STATE OF UTAH
DEPARTMENT OF NATURAL RESOURCES
DIVISION OF OIL, GAS AND MINING

APPLICATION FOR PERMIT TO DRILL		5. MINERAL LEASE NO: ML-21329	6. SURFACE: State
1A. TYPE OF WORK: DRILL <input checked="" type="checkbox"/> REENTER <input type="checkbox"/> DEEPEN <input type="checkbox"/>		7. IF INDIAN, ALLOTTEE OR TRIBE NAME:

2. NAME OF OPERATOR: KERR MCGEE OIL & GAS ONSHORE L.P.		9. WELL NAME and NUMBER: NBU 1021-28I	
3. ADDRESS OF OPERATOR: 1368 S 1200 E CITY VERNAL STATE UT ZIP 84078		PHONE NUMBER: (435) 781-7024	10. FIELD AND POOL, OR WILDCAT: NATURAL BUTTES

APPROXIMATE TOTAL 8" PIPELINE DISTANCE = 12,100' +/-

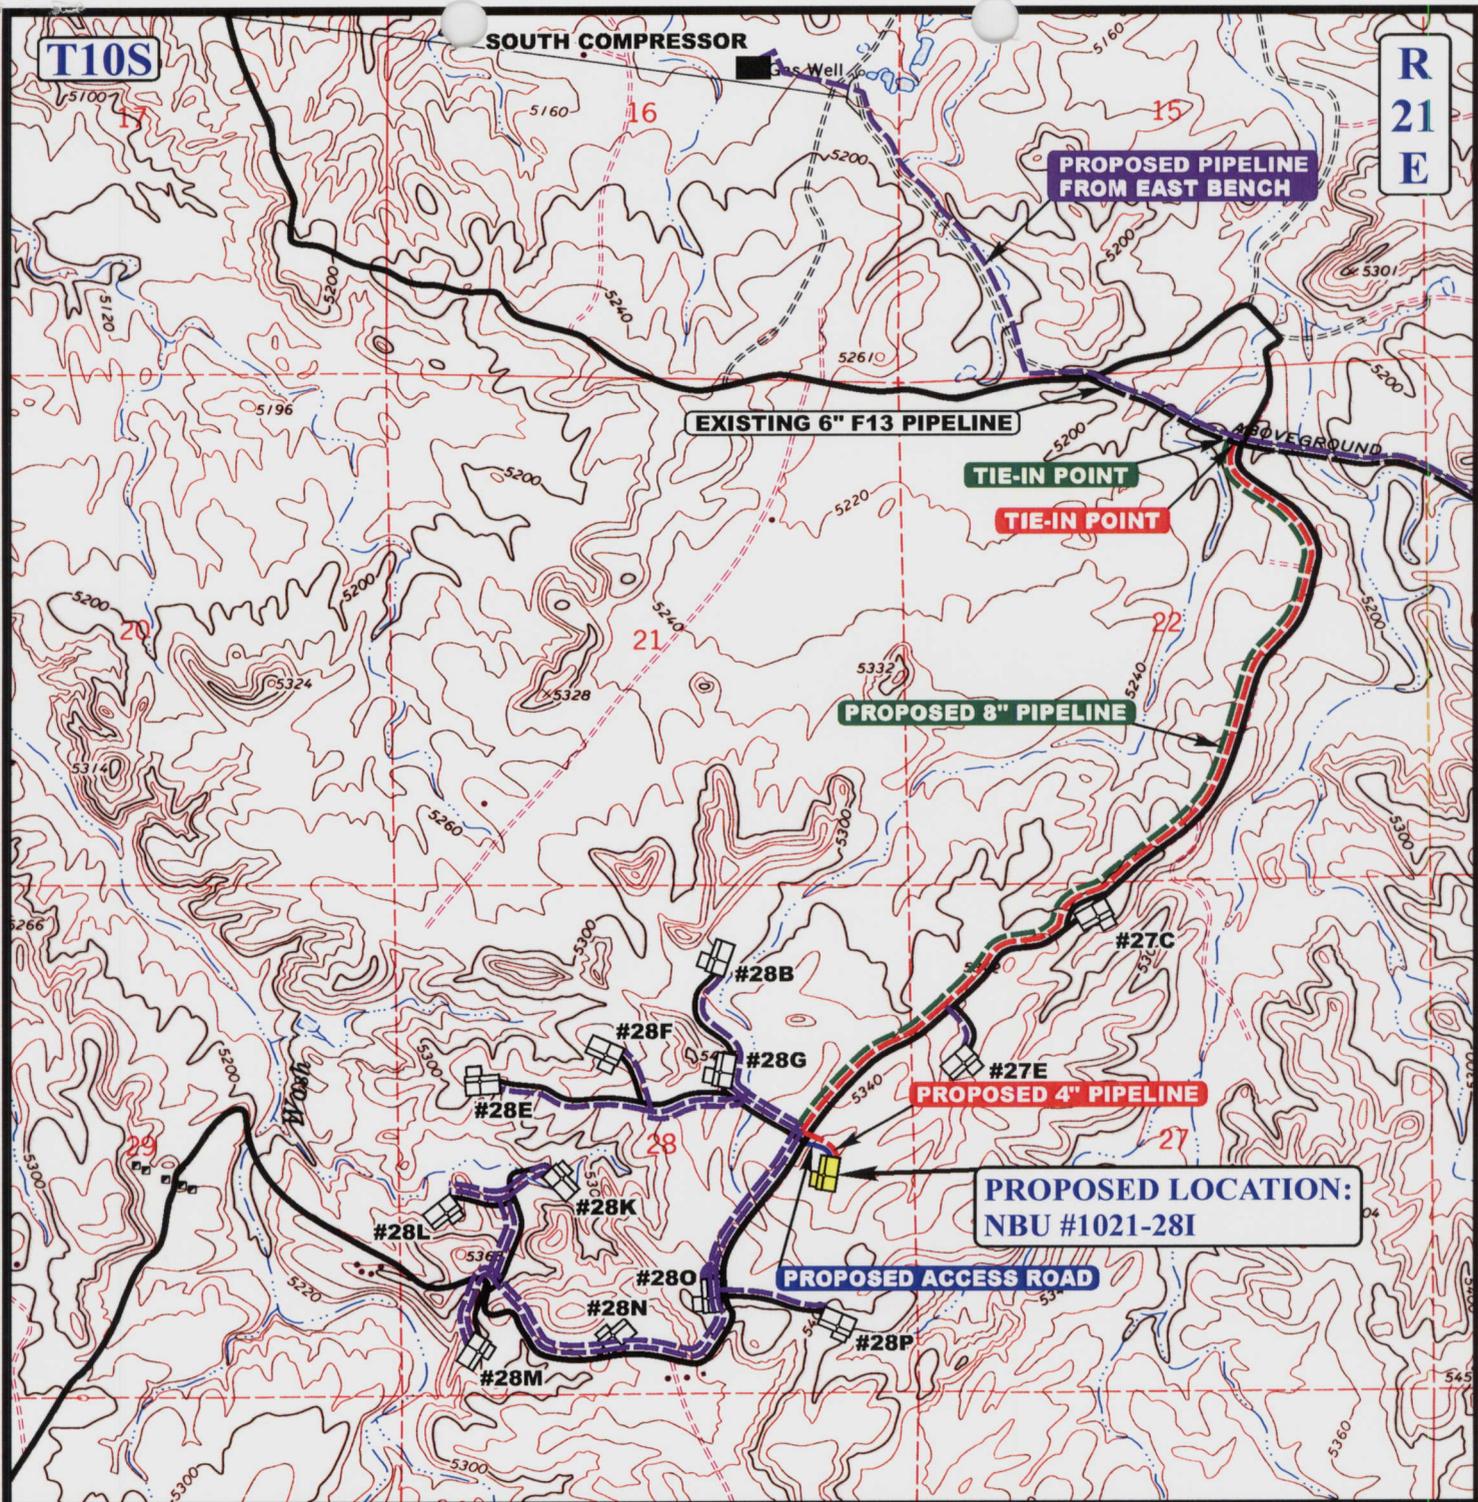
An onsite was conducted on 4/5/07 with the Division of Oil, Gas and Mining Representative and SITLA Representative. It was decided to change the proposed pipeline from a 4" pipeline that was approximately 332' +/- to a 4" pipeline approximately 12,450' +/- and an 8" pipeline approximately 12,100' +/- . These pipelines also cross onto Federal lands in Sec 27 and tie into a point in Sec 22 of T10S-R21E.

TOPOGRAPHIC	01	03	07
MAP	MONTH	DAY	YEAR
SCALE: 1" = 2000'	DRAWN BY: C.P.		REVISED: 04-30-07

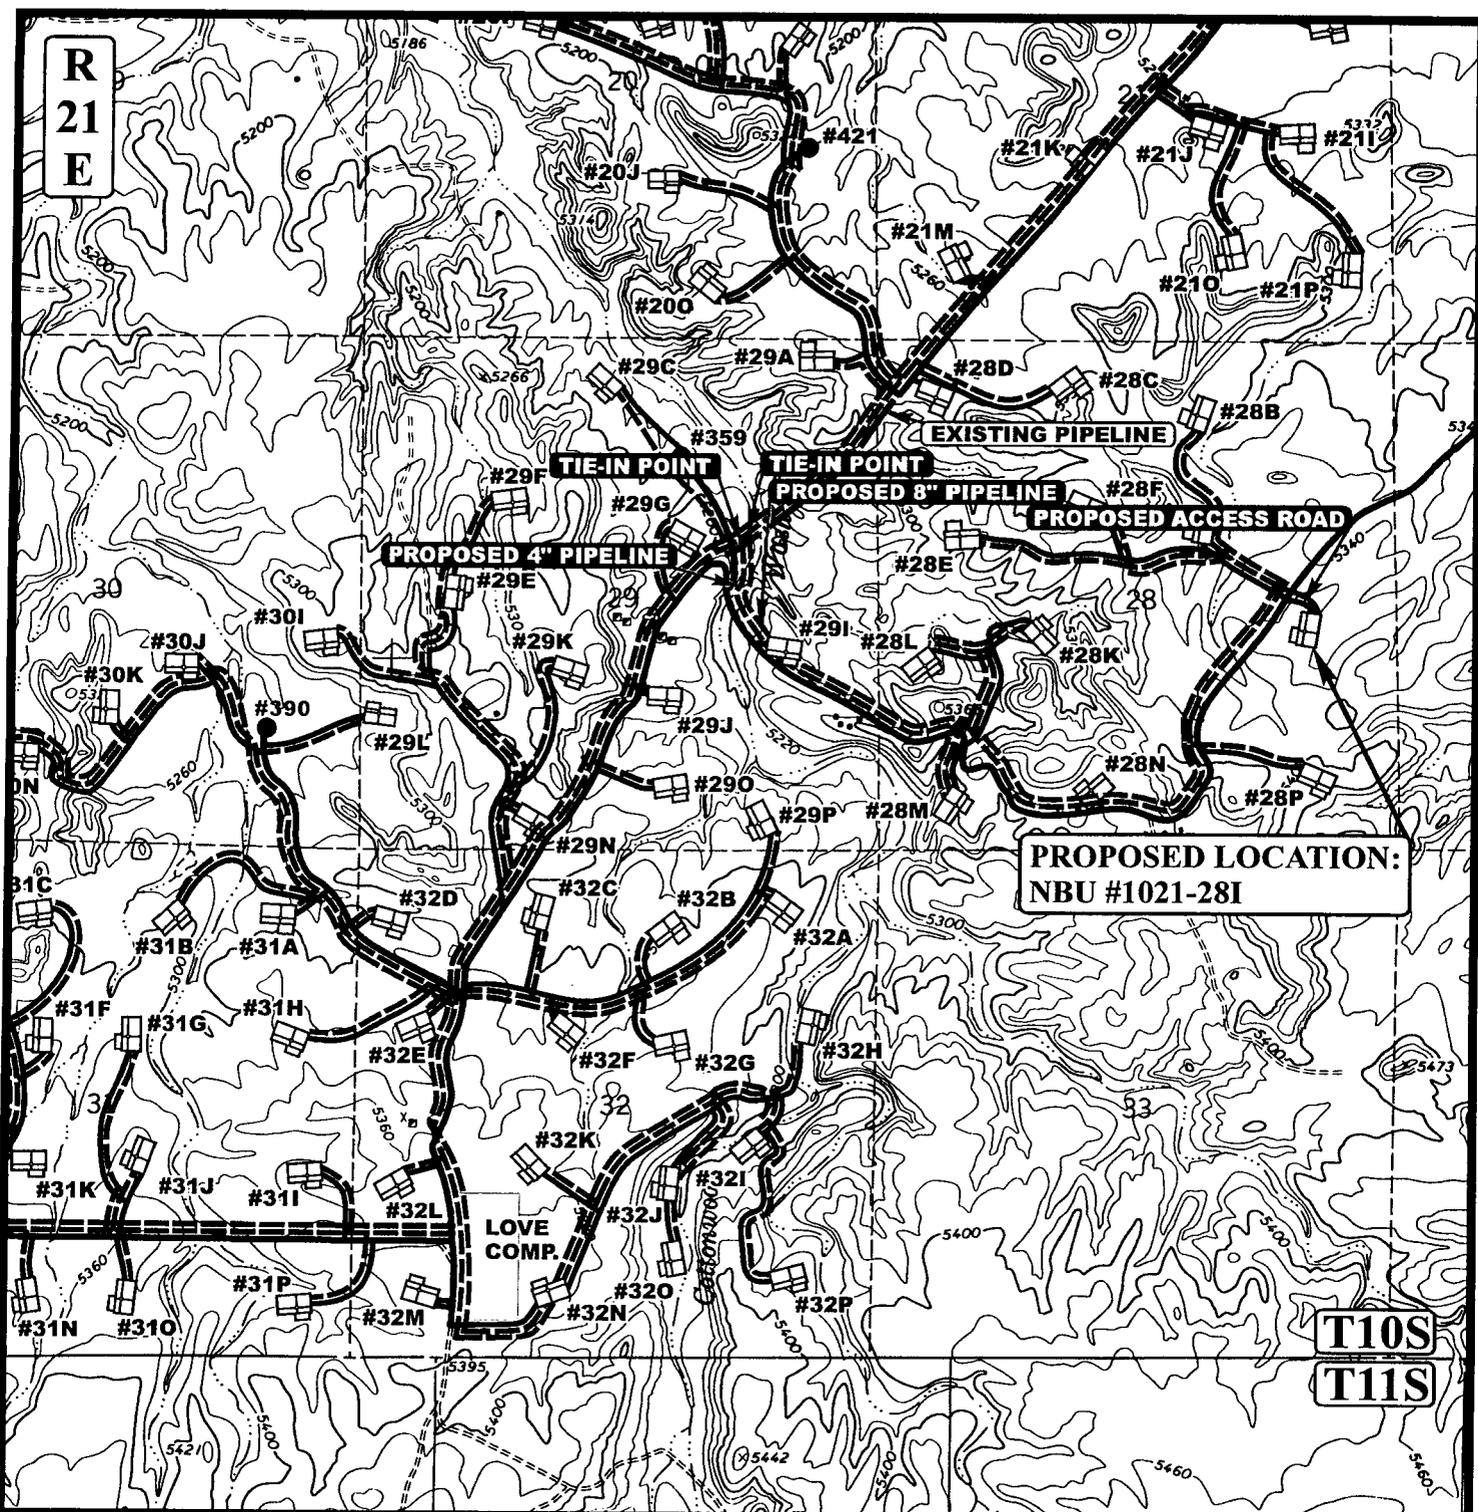
An onsite was conducted on 4/5/07 with the Division of Oil, Gas and Mining Representative and SITLA Representative. It was decided to change the proposed pipeline from a 4" pipeline approximately 12,450' +/- and an 8" pipeline approximately 12,100' +/- to a 4" pipeline approximately 9,150' +/- and an 8" pipeline approximately 8,850' +/-.

Please replace the sundry dated 4/18/07 to this sundry dated 5/8/07.
